Draft Final Copy
Interim Record of Decision
Davis Global Communications Site

SUBJECT: Draft Final Copy, Interim Record of Decision (IROD), Davis Global
Communications Site

The subject document is forwarded to you for your review. Comments on the draft copy have been incorporated. This document is identified as a primary document according to the guidelines in the Federal Facilities Site Remediation Agreement (FFSRA).

**FIGURE 2-1
SITE MAP**

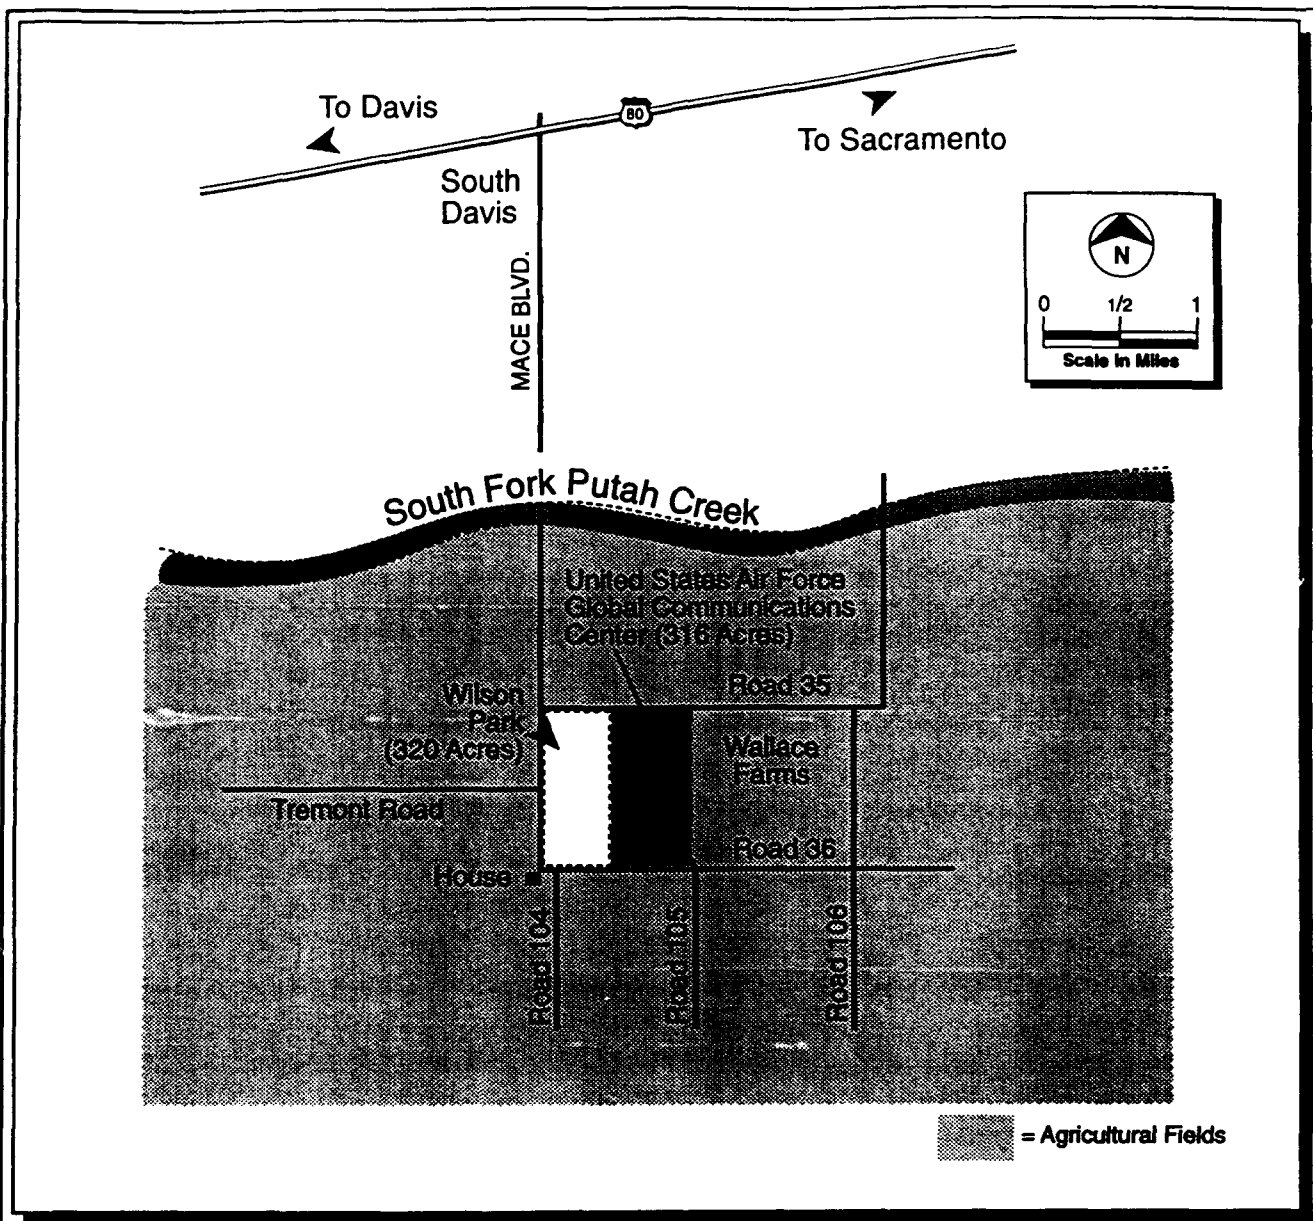
1. Fig. 2-1. The site map should show proximity to the "local" community, not to a golf course.

Noted change made to Figure 2-1.

FIGURE 2-7
VERTICAL GRADIENTS
AT WELL CLUSTER MW3
 DAVIS GLOBAL COMMUNICATIONS SITE
 McCLELLAN AIR FORCE BASE
 YOLO COUNTY, CALIFORNIA

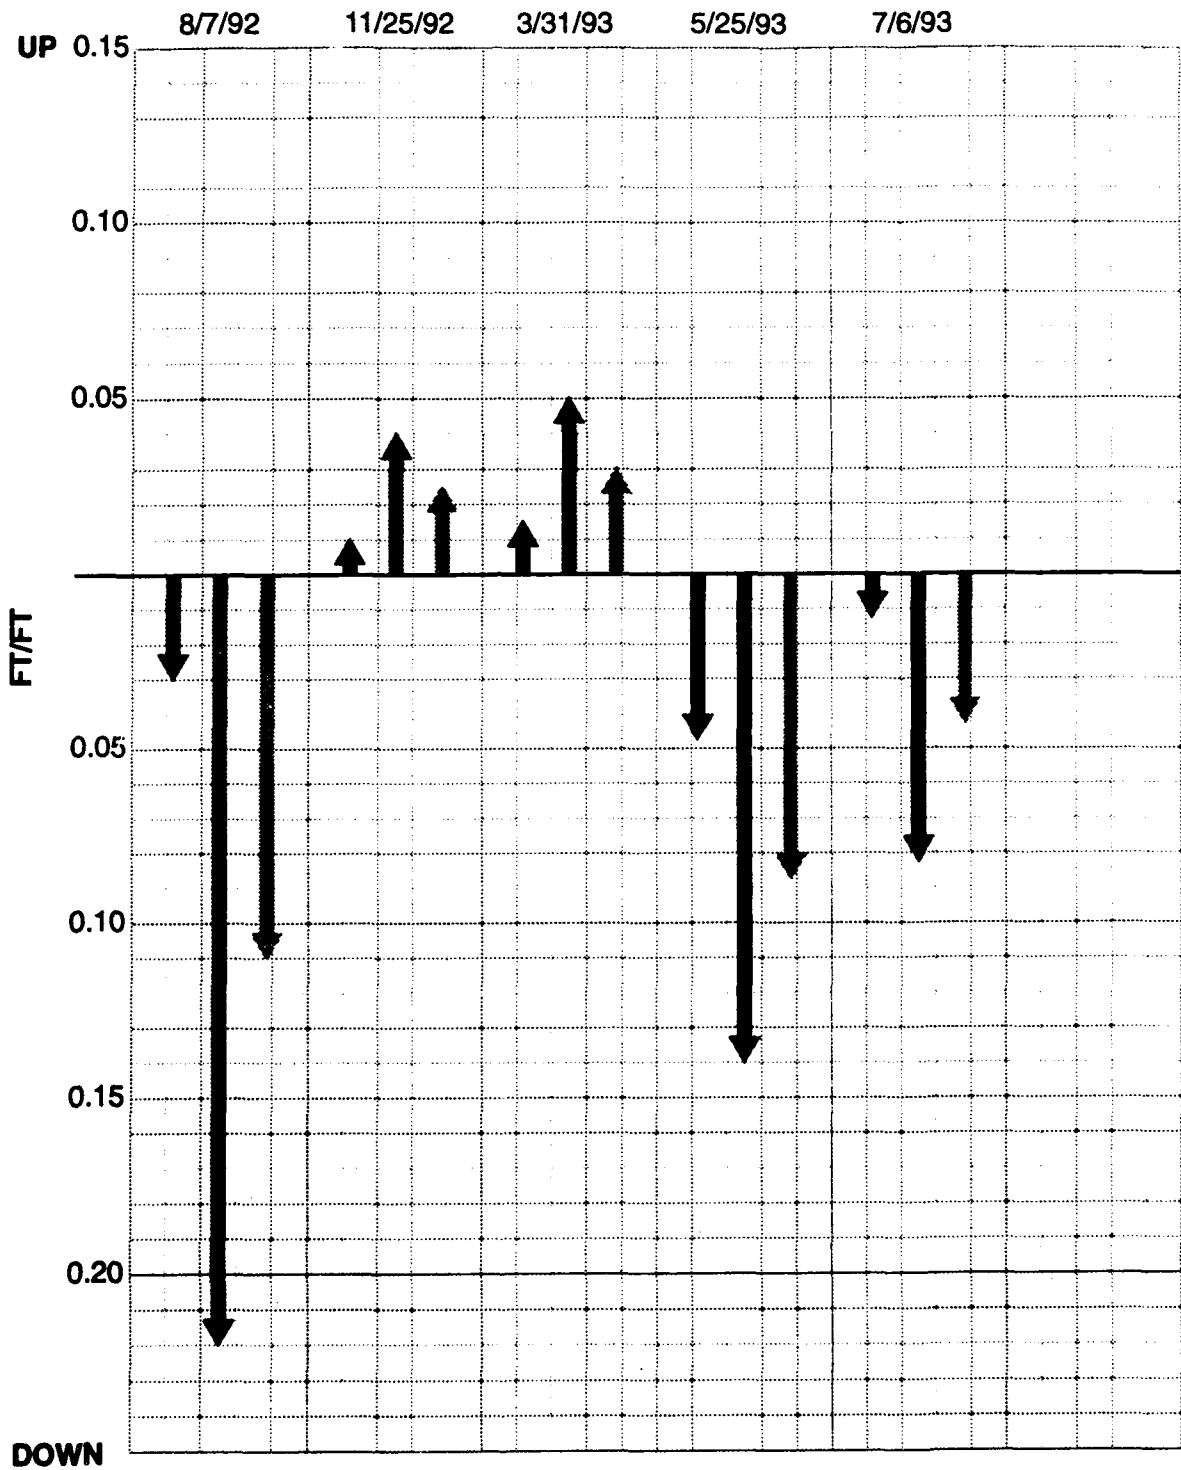
10. Pgph 3. Vertical gradients for the B zone should also be discussed and included in Figure 2-6.

Groundwater levels for the B zone are nearly identical with those from the C zone. Therefore, vertical gradients between the B zone and lower zones are the same as those shown in Figure 2-7 for the C zone and lower zones.
